Title		
Size A4	Number	Revision
Date: File:	2/20/2023 D:\2023\AD936X_SchDoc	Sheet of Drawn By:

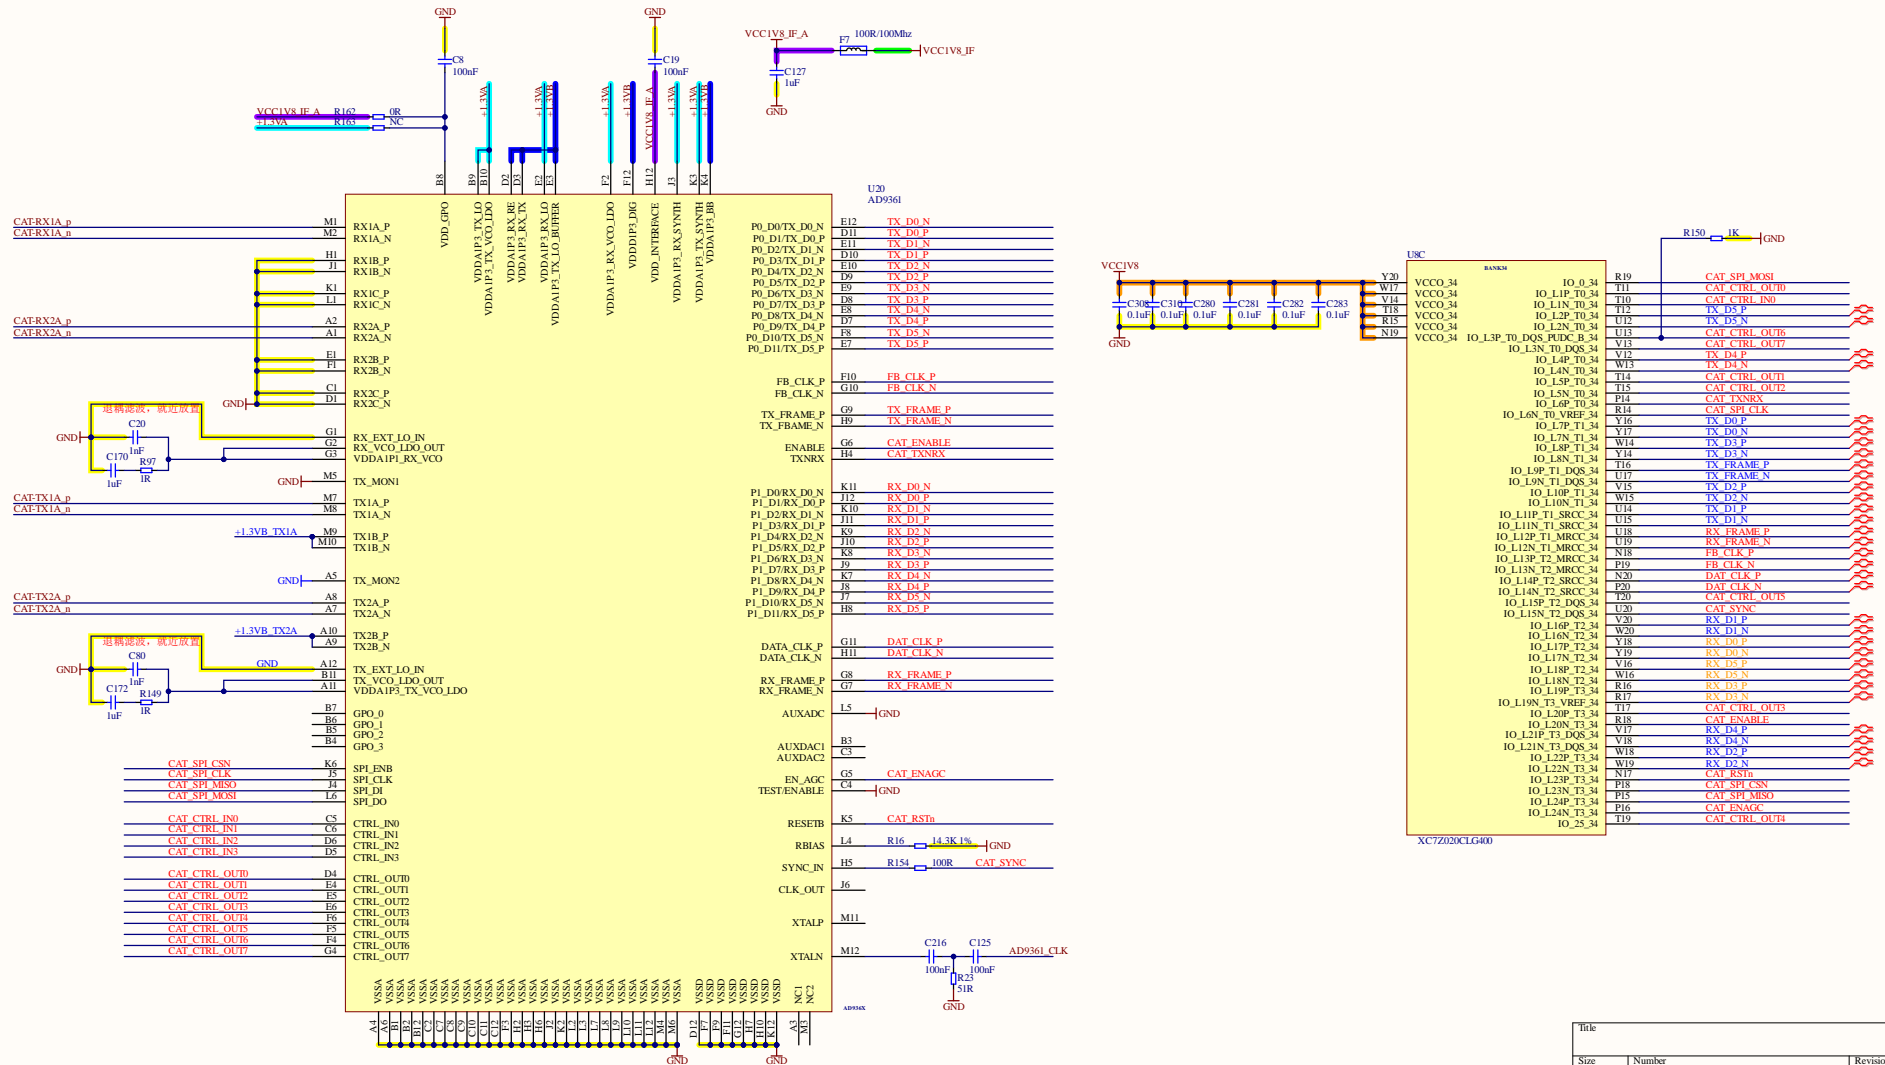
布局在背面

Title		
Size	Number	Revision
A4		
Date:	2/20/2023	Sheet of
File:	D:\2023\...\OGT_SD.SchDoc	Drawn By:

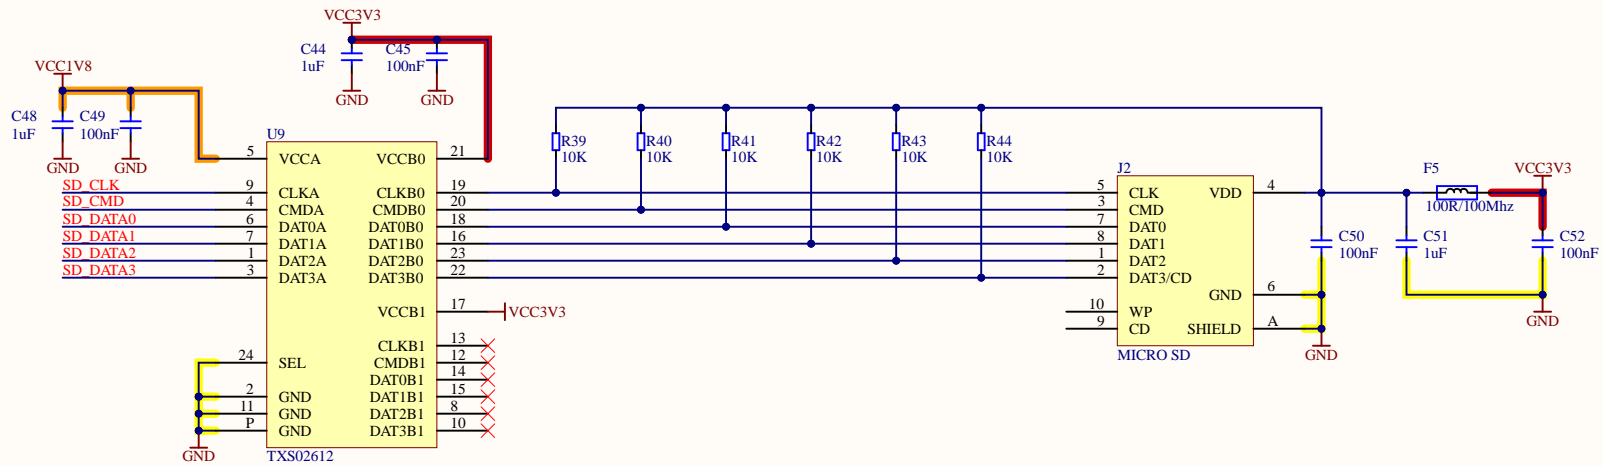
红色线要求粗短

Title			
Size A4	Number		Revision
Date:	2/20/2023	Sheet of	
File:	D:\2023\...\POWER RF.SchDoc	Drawn By:

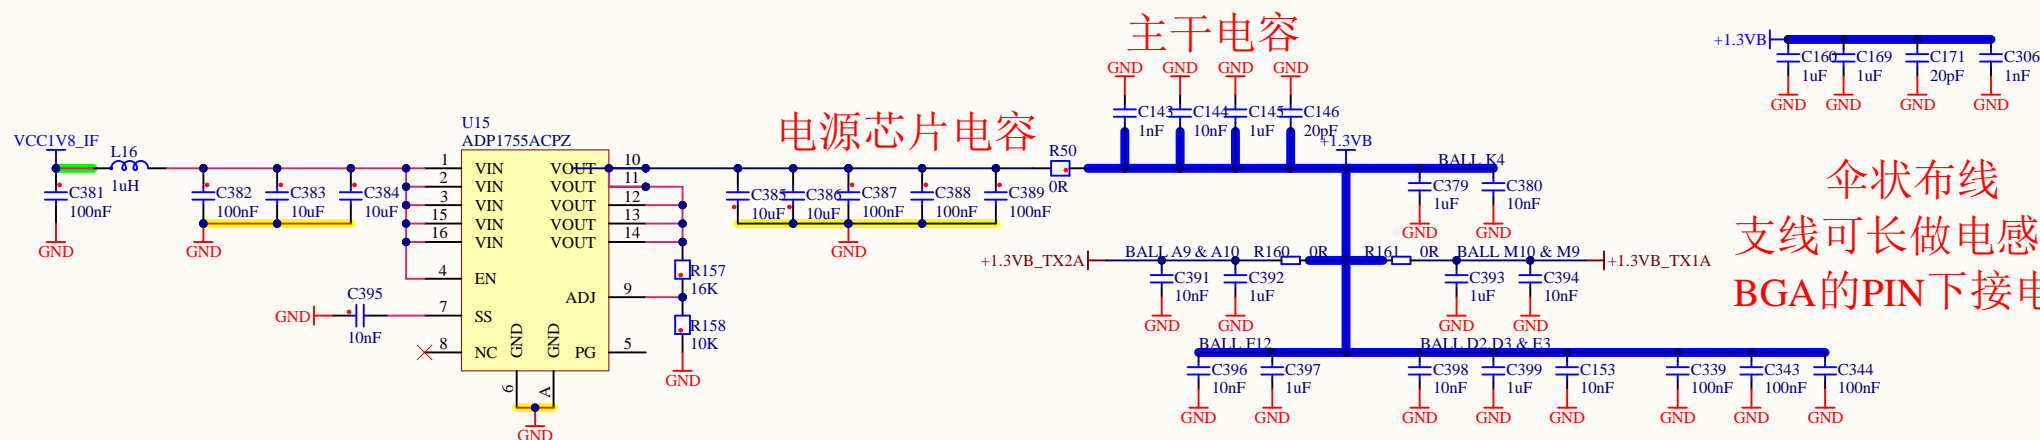
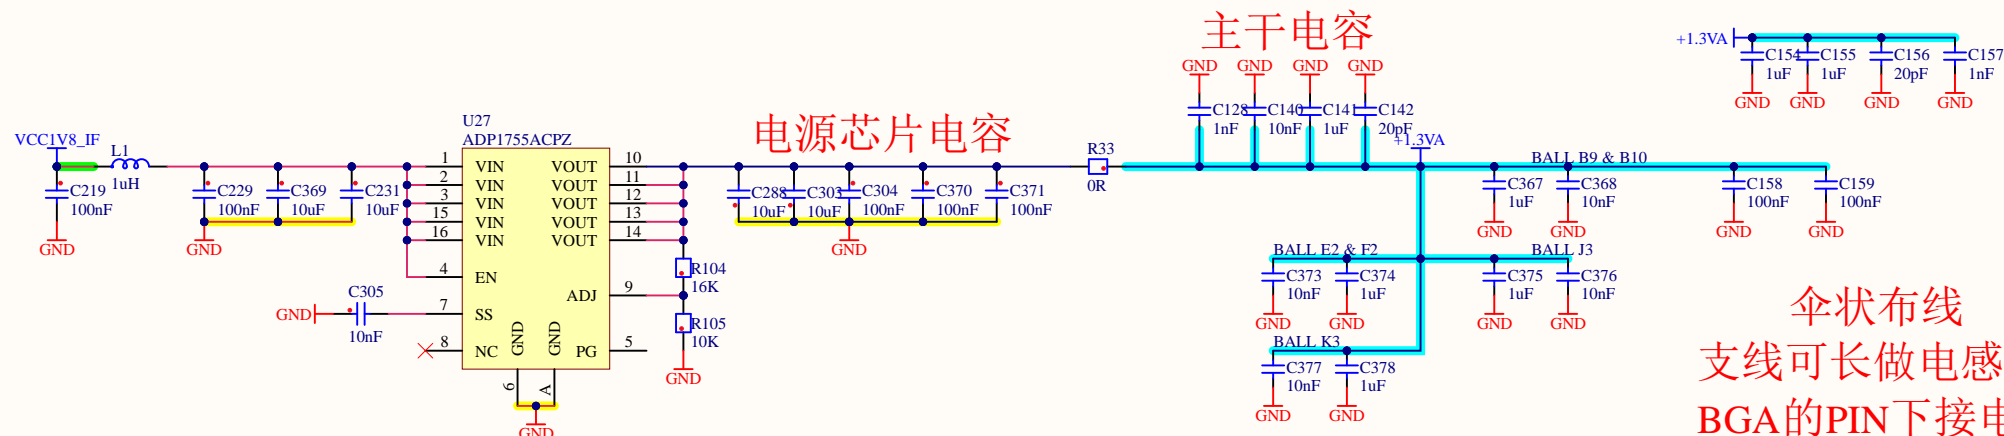
退耦电容要精确到AD9361的PIN上
